Access Compliance Report

Public Rights-of-Way

(Curb Ramps)

Intersection ID: 42740	Main Street: CALDWELL RIDGE PY	Cross Street: DANIEL PLACE DR	Location: NW
ADA ID: 89A7B1627B92	Ramp Type: PerpDiag	Initial Pass/Fail: Pass	Overall Compliance: No
Severity Score: 21.75			
Codes/Mitigation Info/Possible Solution		Field Measurements/Component Compliance

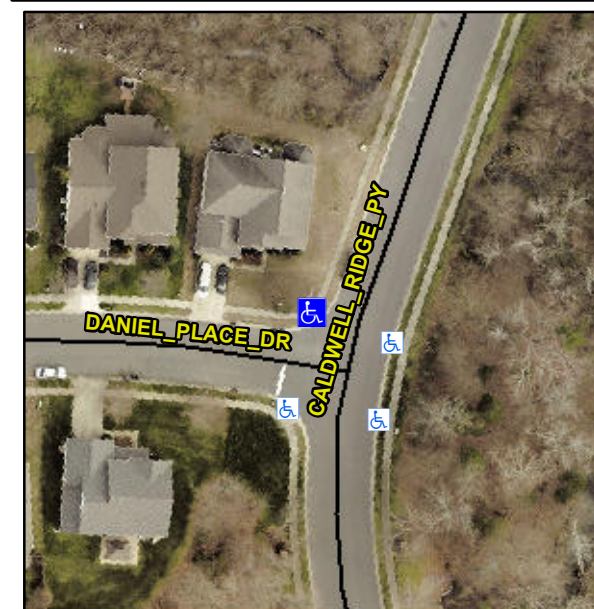
Not Found, R304.5.3, R304.2.1, R305, R302.7.2

Compliance	Description	Data	Compliance	Description	Data
N/A	Ramp Length (in)	45.0	Yes	Ramp Slope (%)	6.1
Yes	Ramp Width (in)	52.0	No	Ramp XSlope (%)	3.7
N/A	Flare Type LT	Sloped	N/A	Flare Type RT	N/A
N/A	Flare Slope LT (%)	6.5	Yes	Flare Slope RT (%)	1.0
N/A	Flare Traversable LT?	Yes	N/A	Flare Traversable RT?	Yes
No	Landing Length (in)	47.0	No	DWS Provided?	No
No	Landing Width (in)	44.0	N/A	DWS Contrast?	No
Yes	Landing Slope (%)	1.0	N/A	DWS Length (in)	N/A
No	Landing X Slope (%)	4.7	N/A	DWS Full Width?	No
N/A	Landing Curb? (Y/N)	No	N/A	DWS Offset (in)	N/A
N/A	Shared Landing?	No			
Yes	Gutter Ponding?	No	Yes	Gutter Slope (%)	1.7
No	Gutter Lip Ht (in)	0.5	No	Gutter X Slope (%)	4.1
N/A	Painted X Walk1?	No	N/A	Painted X Walk2?	No
	X Walk 1 Direction	To SW		X Walk 2 Direction	To E
N/A	X Walk 1 Width (in)	N/A	N/A	X Walk 2 Width (in)	N/A
	X Walk 1 Slope (%)	3.6		X Walk 2 Slope (%)	0.2
	X Walk 1 X Slope (%)	3.0		X Walk 2 X Slope (%)	2.2

Remove & Replace Curb Ramp With Two New Directional Ramps or Equivalent. Remove & Replace Gutter.
